**TOWN OF MOUNTAIN VILLAGE
REGULAR DESIGN REVIEW BOARD MEETING
AGENDA**

3.	10:05	60	Miller	Quasi-Judicial	Consideration of a Design Review: Initial Architectural and Site Review Application for a new single-family residence on Lot AR-2, 113 Lawson Overlook, pursuant to CDC Section 17.4.11. This item was continued from 3.26.2020 and 5.7.2020.

4.	11:05	60	Miller	Quasi-Judicial	Consideration of a Design Review: Initial Architectural and Site Review Application for a new single-family residence on Lot 601, Knoll Estates Unit Two, pursuant to CDC Section 17.4.11. This item was continued from 5.7.2020.

FROM: John Miller, Senior Planner

1 BUILDING HEIGHT DIAGRAM
SCALE: 1/8" = 1'-0"

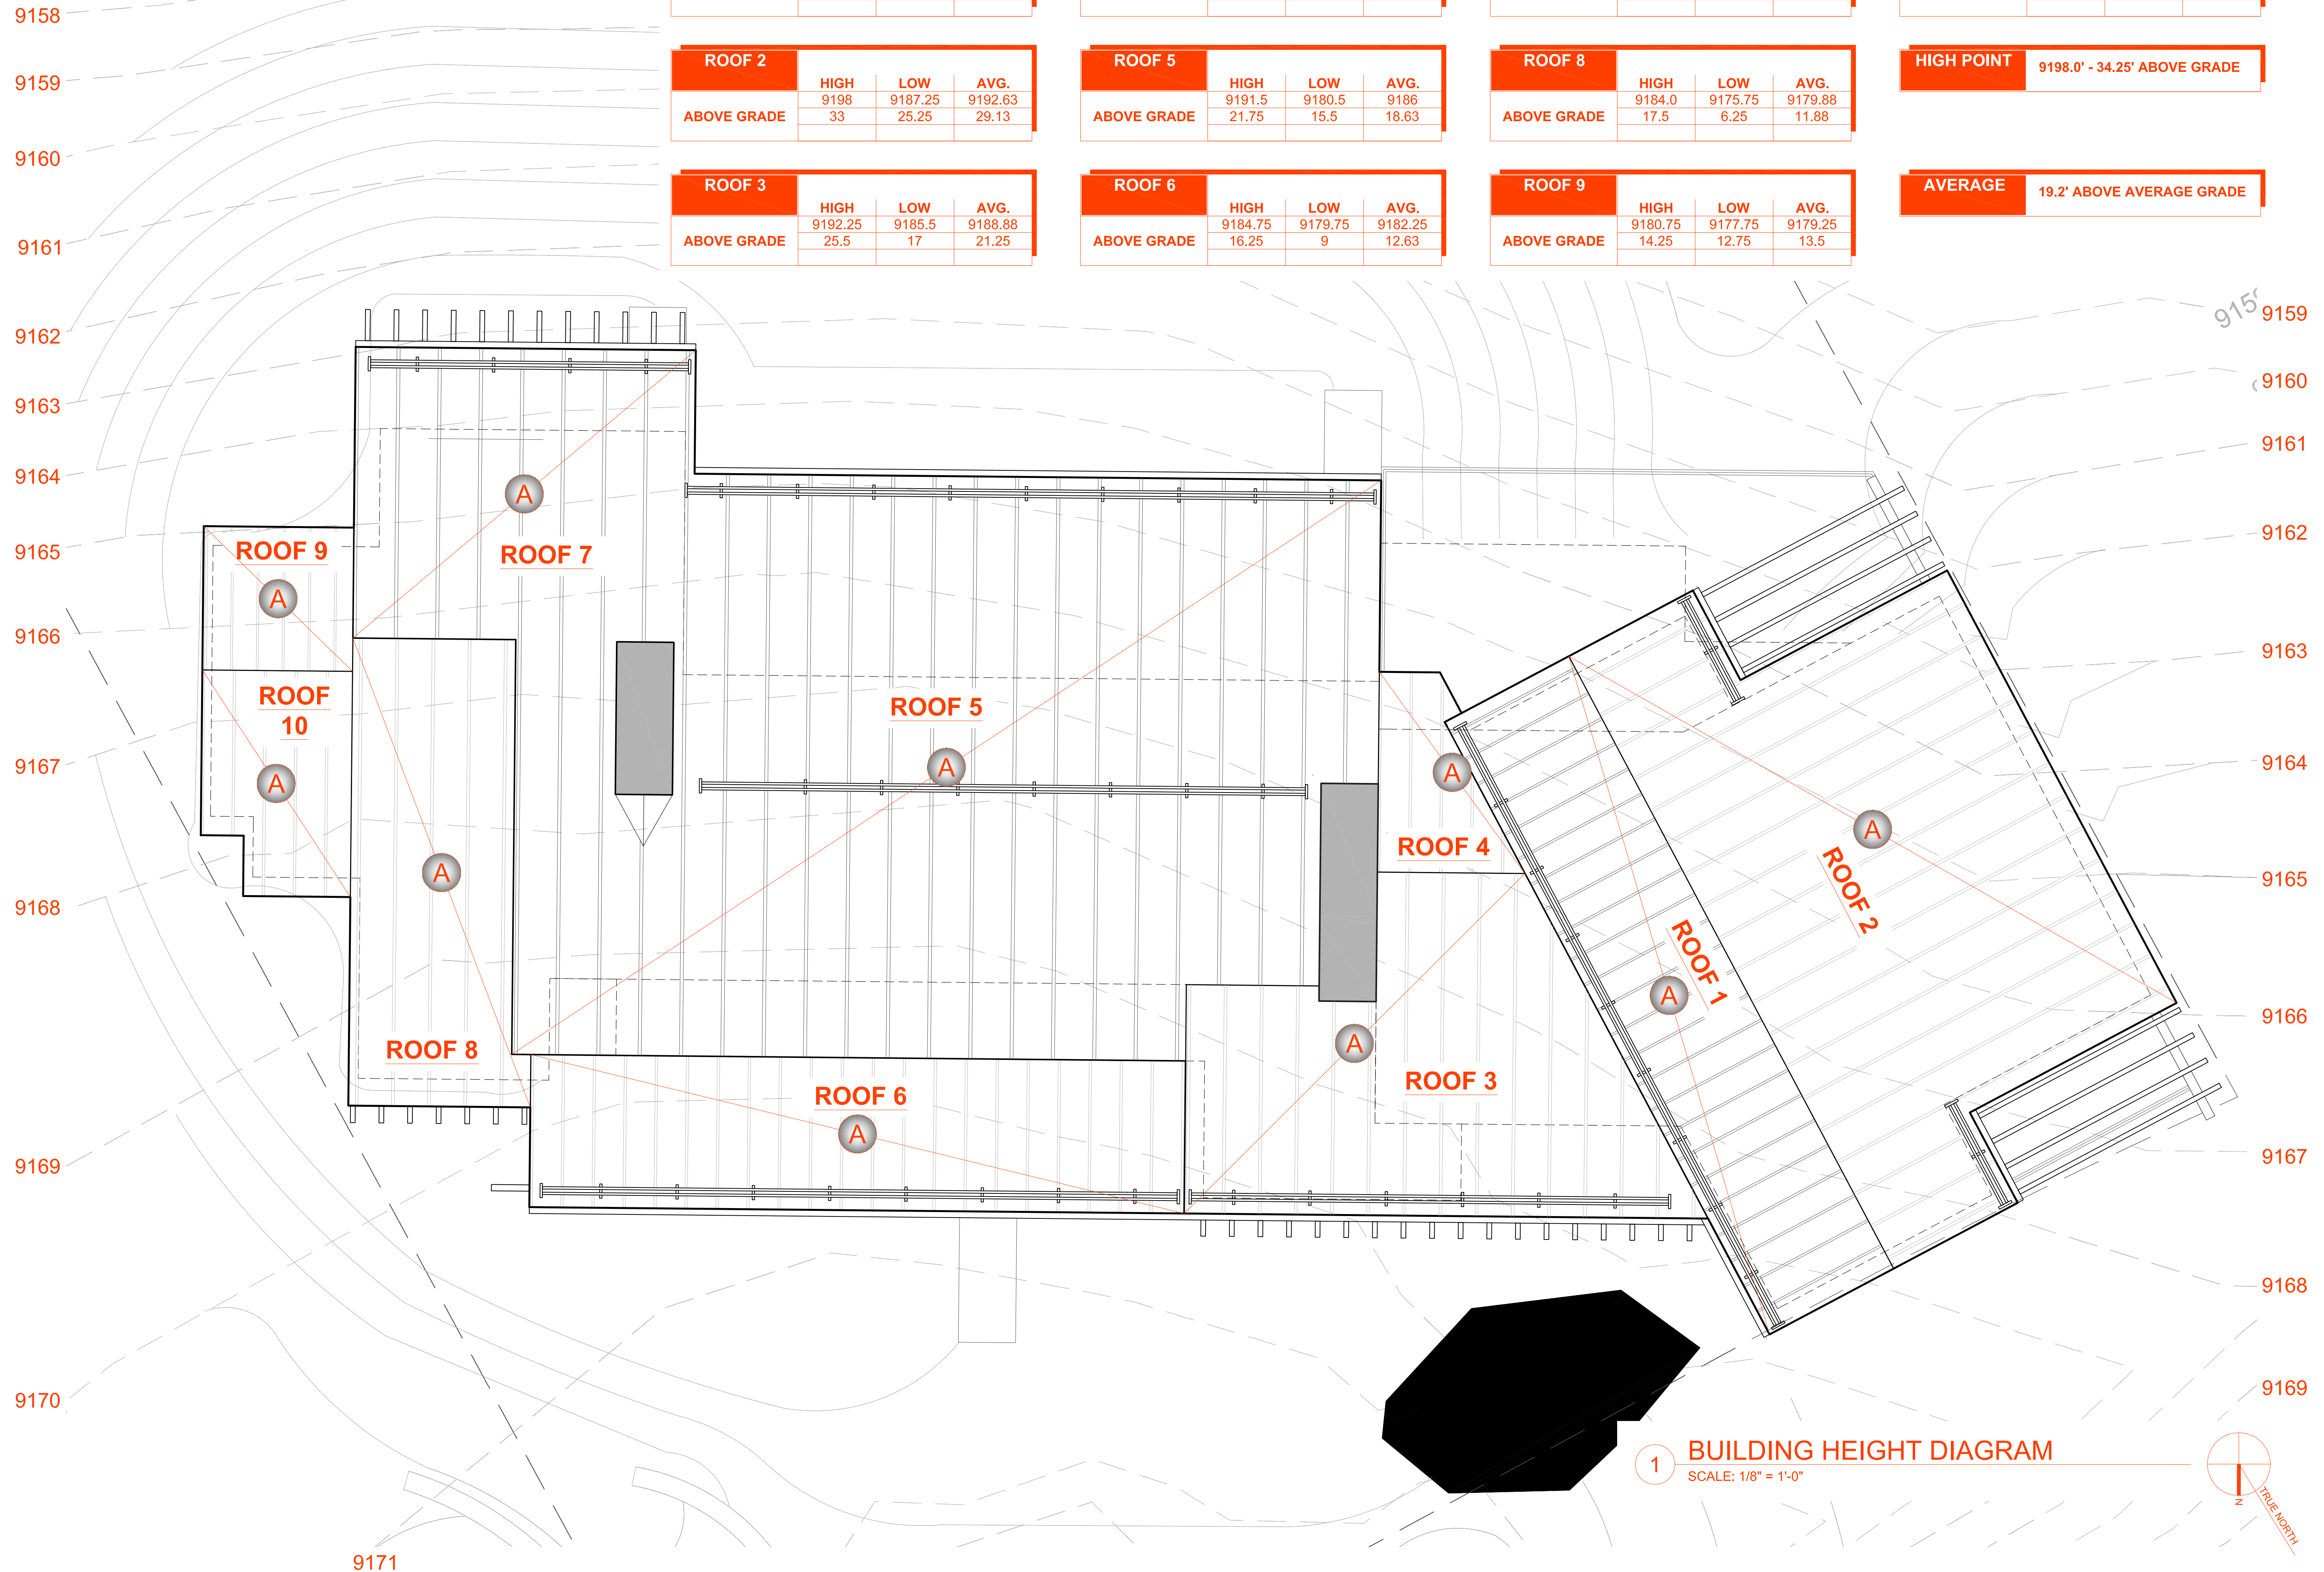
Sections 17.3.11 and 17.3.12 of the CDC provide the methods for measuring Building Height and Average Building Height, along with providing the height allowances for specific types of buildings based on their architectural form. The proposed design incorporates both Gabled and Shed roof forms which are granted different height allowances in the CDC. Gabled roof forms are granted a maximum building height of 40 feet with shed roof forms limited to 35 feet. The maximum average height must be at or below 30 feet for shed roof forms and 35 feet for gable roof forms. The average height is an average of measurements from a point halfway between the roof ridge and eave. The points are generally every 20 feet around the roof. The maximum height is measured from the highest point on a roof directly down to the existing grade or finished grade, whichever is more restrictive.

- 2) Prior to the submittal for a Final Architectural Review, the applicant shall revise the Building Height Diagram to demonstrate both Maximum Height and Average Maximum Height per the notes provided within this staff memo.

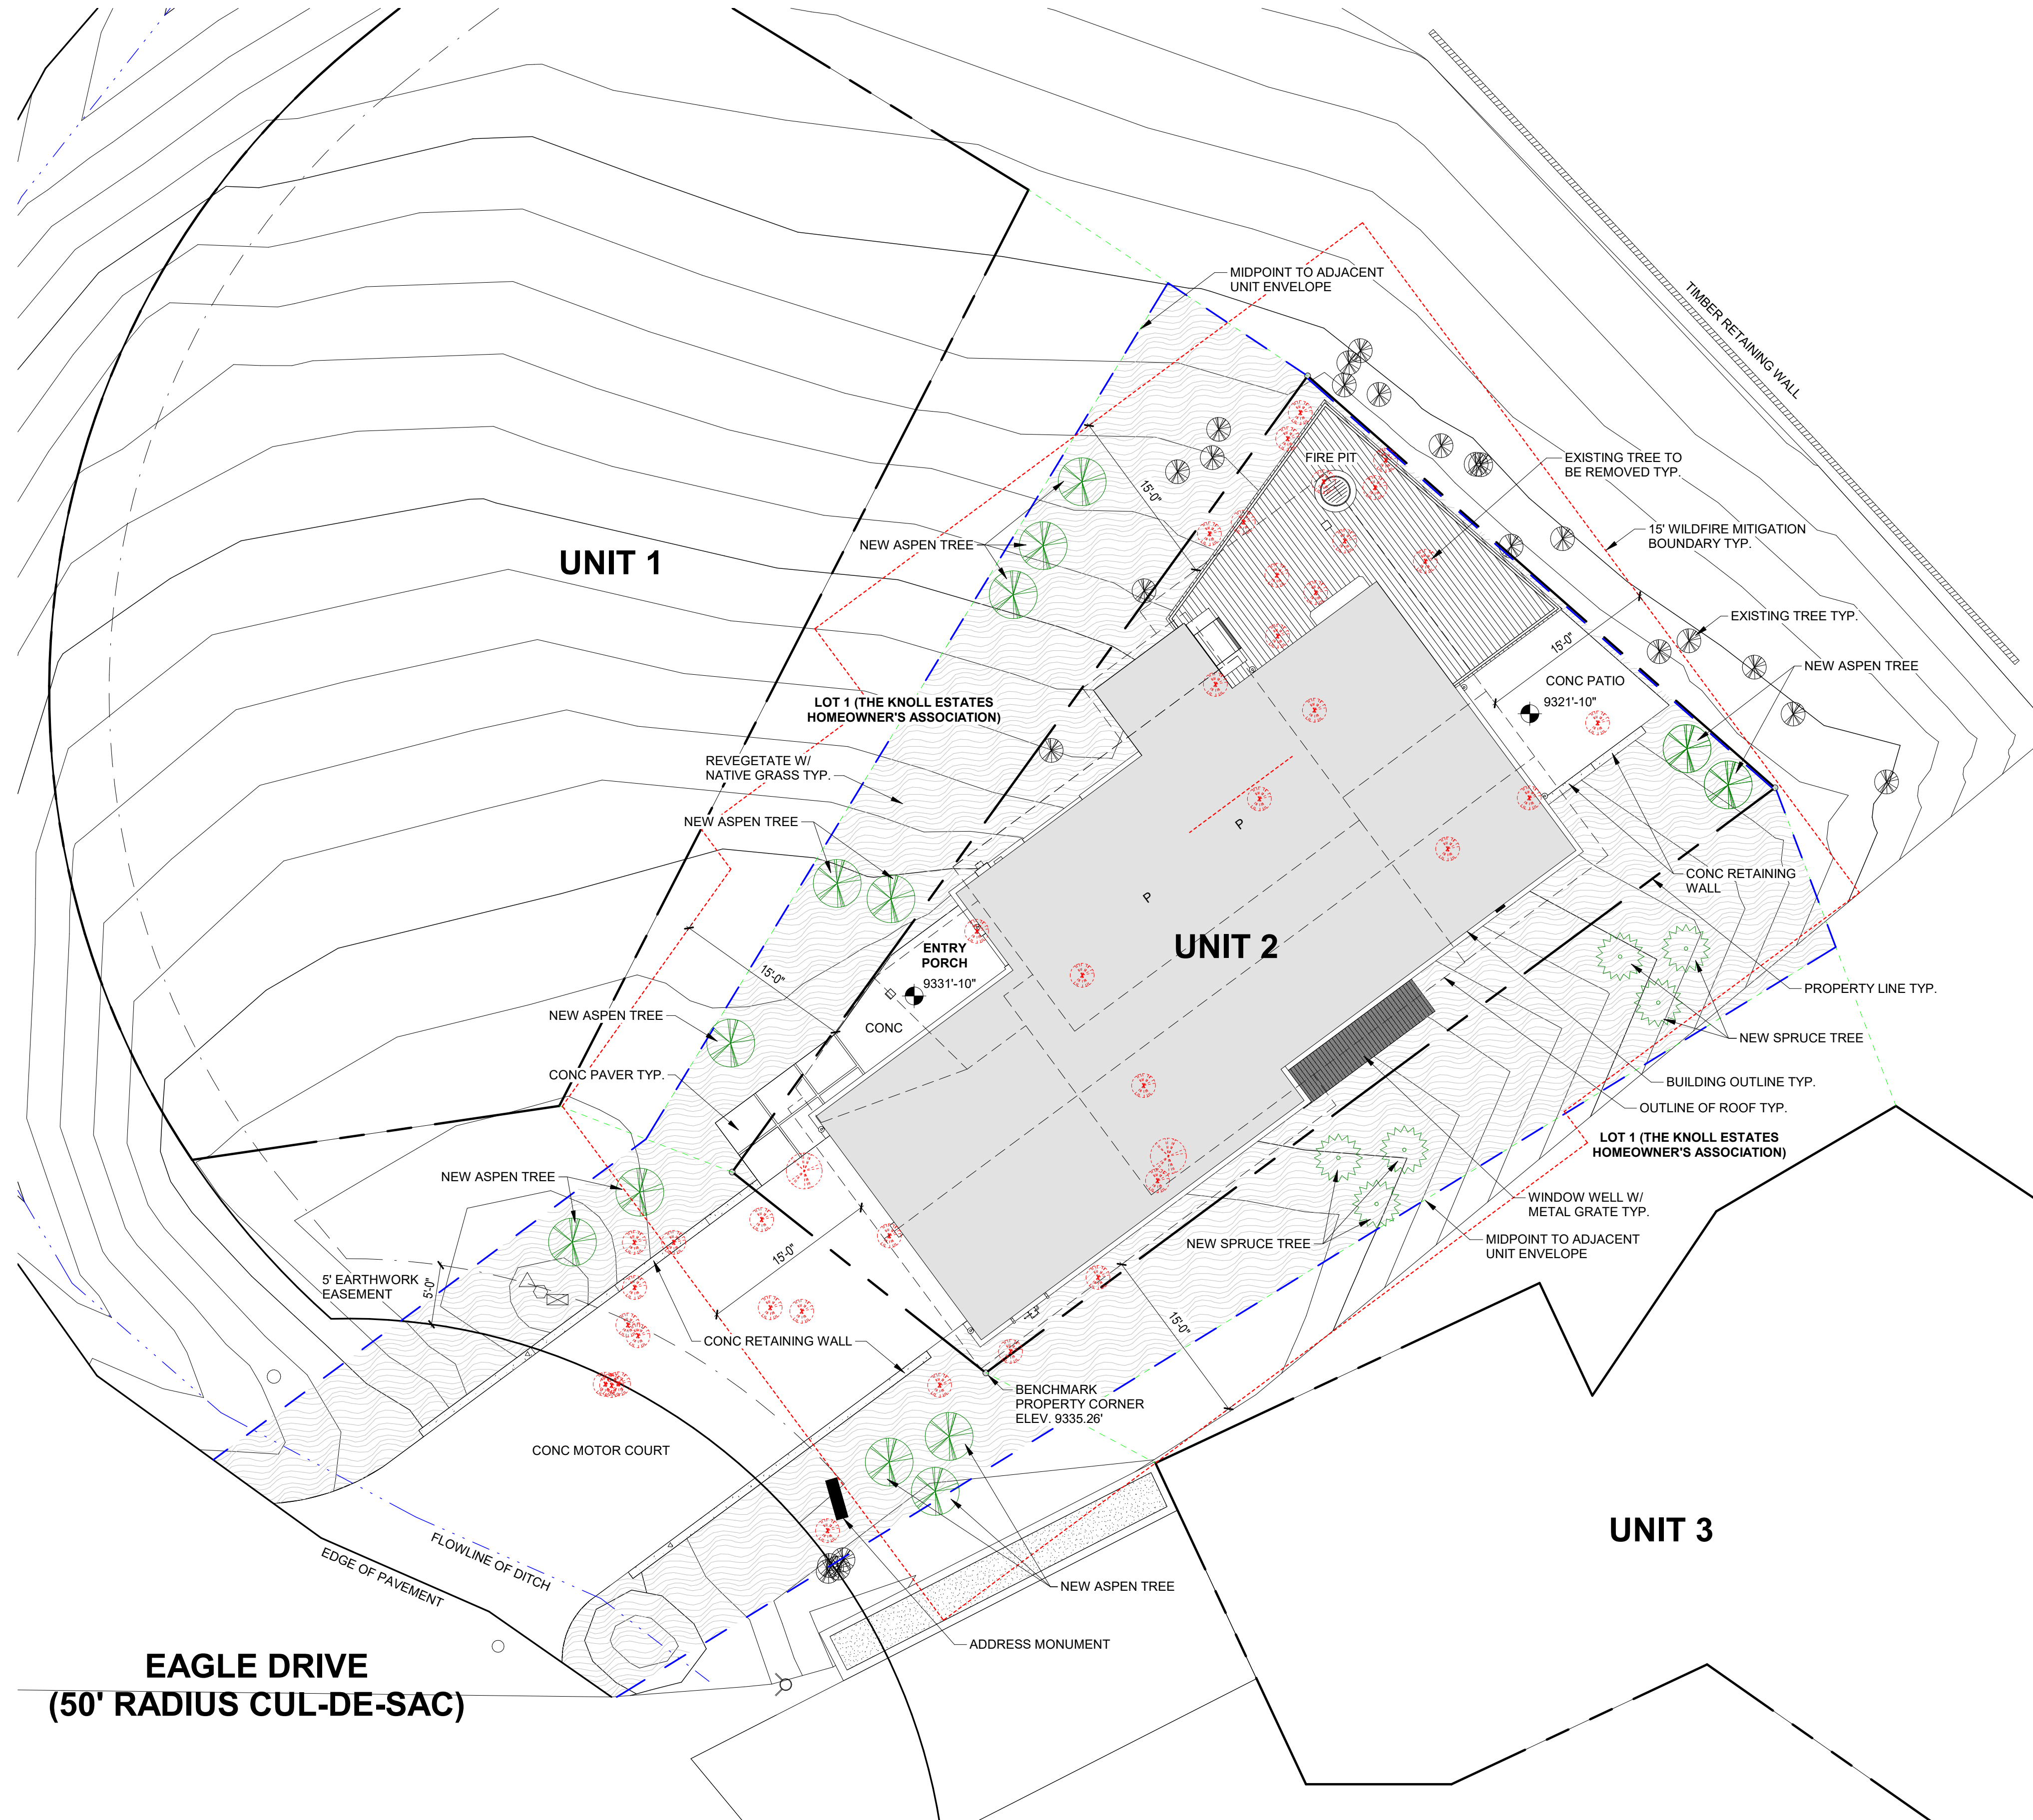
The applicant has provided a preliminary landscaping plan demonstrating the irrigation schedule and notes, along with planting schedules and species lists. The majority of the lot will need to be cleared for the development of the home and the applicant is proposing to replace trees outside of the building footprint and within the LCE of Knoll Estates.

Generally, staff is ok with the proposed planting schedule with the exception of the new evergreen trees proposed between Unit 2 and Unit 3. These trees will need to be removed to better provide defensible space between the homes. The applicant may choose to remove plantings from this area entirely, or alternatively choose from a deciduous species listed in the CDC. There does not appear to be any irrigated turf areas and the majority of the area surrounding the home is to be revegetated to native grasses. It may be helpful to revise the plan to include additional tree species other than aspens to provide some variation to the landscaping.

- 1) Prior to the submittal for a Final Architectural Review, the applicant shall provide an updated landscaping plan demonstrating the removal of all coniferous species within the Zone 1 Wildfire Mitigation Area.
